Code Technologies Committee Report ADA/IBC Coordination – Group A changes:

Following are code change proposals submitted through CTC from ADA/IBC Coordination study group and related changes.

ADA/IBC Coordination

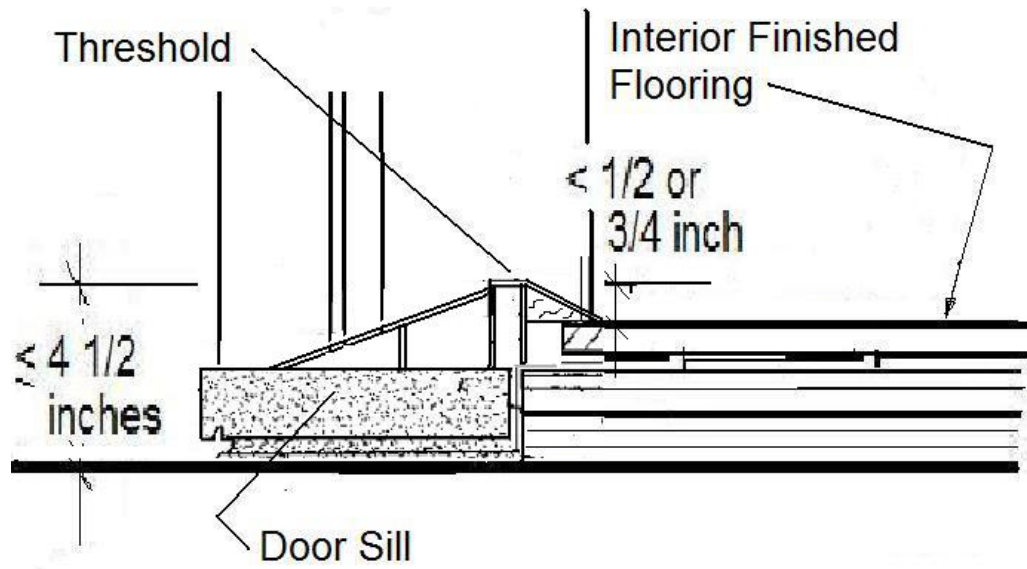
Exception Exceptions:

1. In occupancy Group R-2 or R-3, threshold heights for sliding and side-hinged exterior doors shall be permitted to be up to $7\frac{3}{4}$ inches in height if all of the following apply:
 - 1.1. The door is not part of the required means of egress.
 - 1.2. The door is not part of an accessible route as required by Chapter 11.
 - 1.3. The door is not part of an *Accessible unit*, *Type A unit* or *Type B unit*.
2. In Type B units, where Exception 5 to Section 1008.1.5 permits a 4-inch (102 mm) elevation change at the door, the threshold height on the exterior side of the door shall not exceed $4\frac{3}{4}$ (120 mm) inches in height above the exterior deck, patio or balcony for sliding doors or $4\frac{1}{2}$ inch (114 mm) above the exterior deck, patio or balcony for other doors.

Reason: Currently an exception to the threshold height provisions of Section 1008.1.7 exists for doors where a $7\frac{3}{4}$ inch step down is permitted by exception 3 to Section 1008.1.5. Specifically this is limited to exterior doors that are not part of the required means of egress, and which are not serving *Accessible units*, *Type A units* or *Type B units*.

This proposal adds a second exception for doors where a 4 inch step down is permitted between Type B dwelling units and exterior decks, patios and balconies by exception 5 to Section 1008.1.5. This proposal would permit the height of the threshold itself to exceed $\frac{1}{2}$ or $\frac{3}{4}$ inch in height, as long as the resultant profile from the interior floor to the exterior surface is maintained as required by current code text.

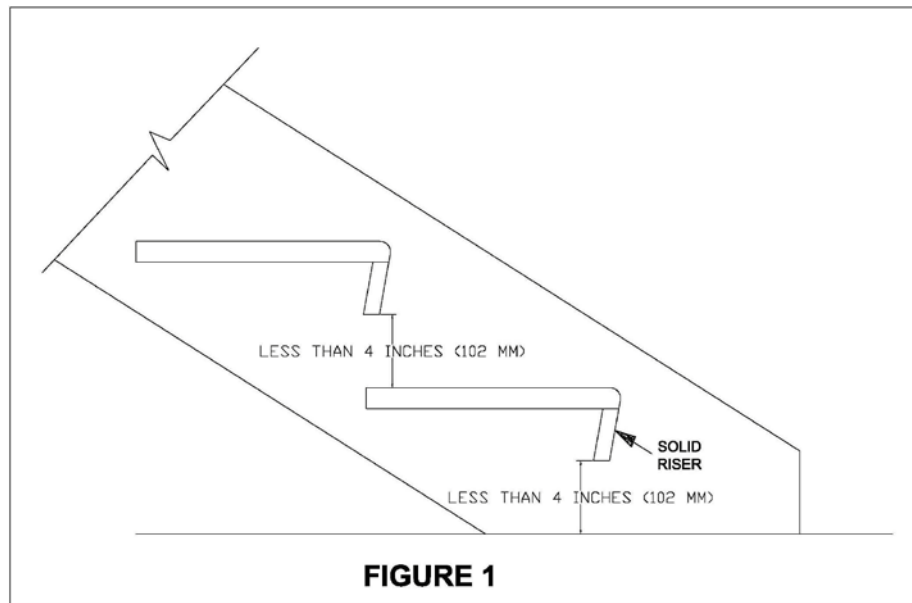
~~1009.7.5.2~~ **1009.7.6.2 (IFC [B] 1009.7.5.2 1009.7.6.2) Nosing projection uniformity.** All *nosings* projections of the leading edges shall be of uniform size, including the projections of the *nosings* leading edge of the floor at the top of a *flight*.

Reason: Section **1009.7.5 Nosing and riser profile** is a constant source of controversy and misunderstanding. The reference to solid risers does not belong in the section that describes the profile or outline of a step. Notably masked in exception 1 by double negatives is the requirement for the limitation of openings in risers.

This proposal clarifies the scoping for use of solid risers and coordinates with the new ADA guidelines as outlined by the CTC. **Solid risers**, as a new and separate section subsection of **1009.7 Treads and risers** will appear prior to Nosing and riser profile. This allows easier identification of the opening limitation between treads and adjoining floors or landings that was previously misunderstood or not found. Exceptions 2 and 3 are similar to the CTC's proposal but assures that an opening limitation applies to Type B units as well as egress stairs and also provides that if an opening is used in the riser, it is in the lower portion of the riser height, as shown in **Figure 1**, allowing design options that may provide additional heel clearance in descent and the appropriate design of tread nosings compliant with ADA guidelines that are important in ascent.

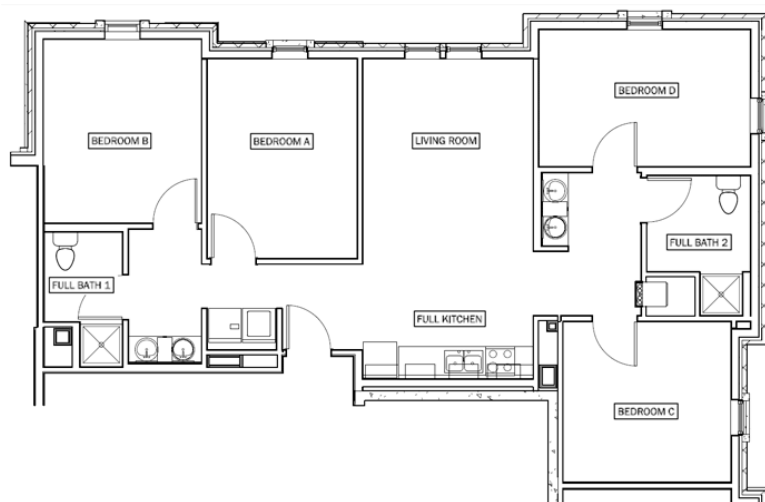
1107.6.4 Group R-4. Accessible units and Type B units shall be provided in Group R-4 occupancies in accordance with Sections 1107.6.4.1 and 1107.6.4.2. Bedrooms within congregate living facilities shall be counted as sleeping units for the purpose of determining the number of units.

1107.6.4.1 Accessible units. At least one of the ~~dwelling~~ or sleeping units shall be an Accessible unit.

1107.6.4.2 Type B units. In structures with four or more ~~dwelling units or~~ sleeping units intended to be occupied as a residence, every ~~dwelling unit and~~ sleeping unit intended to be occupied as a residence shall be a Type B unit.
